Detailed Site Plan Junica Brandywine

DET-2025-006

STAFF REPORT

SUBJECT: Detailed Site Plan DET-2025-006
Type 2 Tree Conservation Plan TCP2-2025-0061
Junica Brandywine

Figure 1: Site Plan

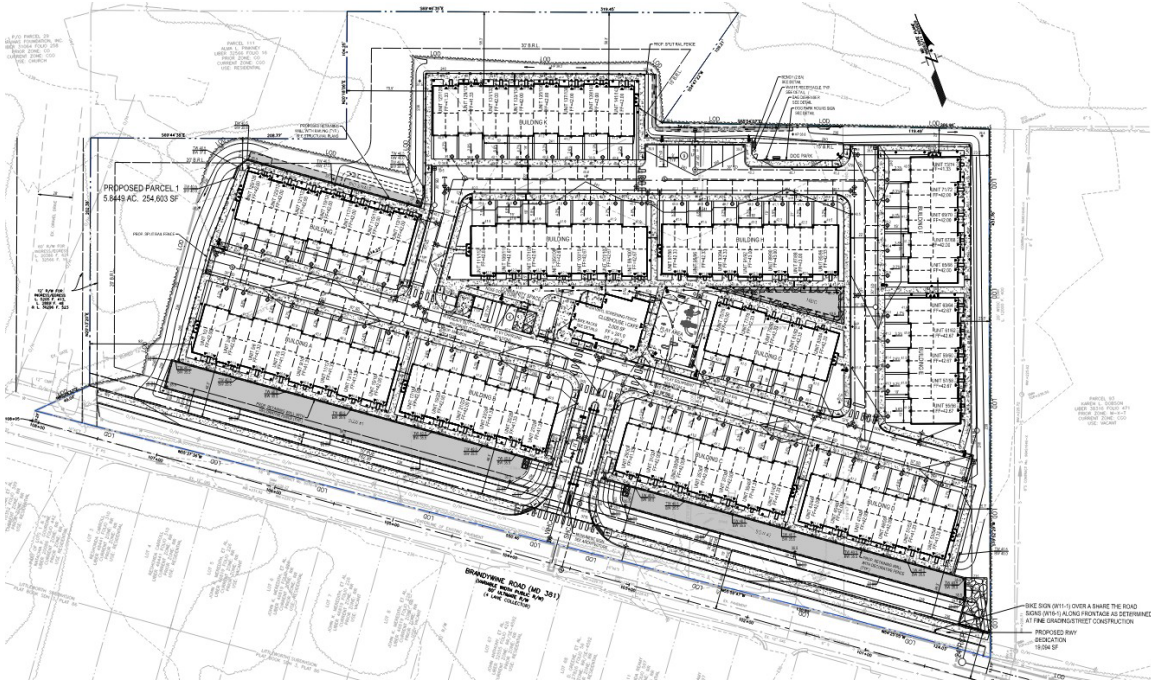
A canopy-mounted sign is proposed above the clubhouse entrance advertising a café. However, this café is not proposed for commercial/public use and per Table 27-61505, canopy signs for residential development (except multifamily) are not applicable. A freestanding sign is also proposed, but is not permitted for residential uses in the CGO Zone. Therefore, conditions are included herein to remove the canopy and freestanding signs from the proposal.

along the property frontage of MD 381. Staff recommend that the applicant provide clarity for the dimensions of the pedestrian facilities on the site plan to ensure they meet the 5-foot-width.

The subject DET proposes a canopy-mounted sign at the clubhouse entrance and a freestanding sign at the development entrance. However, neither the canopy nor freestanding signage are permitted for residential developments within the CGO Zone. A condition is included to remove the proposed signs.

However, the 0.75 credit for the “showering and dressing facilities in nonresidential developments for employees” should not be included as this is not a nonresidential development. Therefore, a condition is included herein requiring the cover sheet be revised to remove this point credit.

1. Prior to certification of the detailed site plan, the applicant and the applicant's heirs, successors, and/or assignees shall revise the plans as follows:
 - a. Revise the canopy and freestanding signage.
 - b. Dimension all proposed sidewalk widths, per Section 27-6207(b)(4)(B) and bicycle facility surfaces, per Section 27-6208(c)(1)(B).
 - c. Revise plans to use the latest curb cut specifications in accordance with the specifications of the permitting agency.
 - d. Replace the Maryland Department of Transportation State Highway Administration signage for the shared-use bicycle facility located at the south-eastern corner of the site plan, in accordance with the W11-1/W161P

- e. Provide a note to the architectural elevations identifying the façade elements proposed for noise mitigation, as well as the specific dwelling units that will receive the façade treatments.
- f. Label fire lane markings, and show the location and details of required signage, fire department connections, and fire hydrant on the detailed site plan.
- g. Provide the proposed floor plan for the clubhouse building.
- h. Revise the proposed green building notes to remove the following notation, as the subject development does not qualify as a nonresidential project.

- i. Notate below the green building chart which building is considered principal and therefore is proposed to be receiving the LEED Bronze rating.
- j. Provide the required number of understory plant units within the common area to meet the 2018 *Prince George’s County Landscape Manual* requirements for Section 4.1.

- k. Revise the plans and plant schedules to ensure that no shrub species exceed the 10 percent maximum limit, in accordance with Section 4.9(e)(3) of the 2018 *Prince George’s County Landscape Manual*.

- l. Revise “Recreational Facilities Provided (DET-2025-006)” table to remove performance bond trigger as it does not conform with the previously approved Preliminary Plan of Subdivision condition.

- m. Provide easements on plans for the open space set-asides area per Section 27-6408(3) of the Prince George’s County Zoning Ordinance.
- n. Revise net acreage to 6.28 acres, as the area to be dedicated for the right-of-way should not be excluded from the total site acreage.
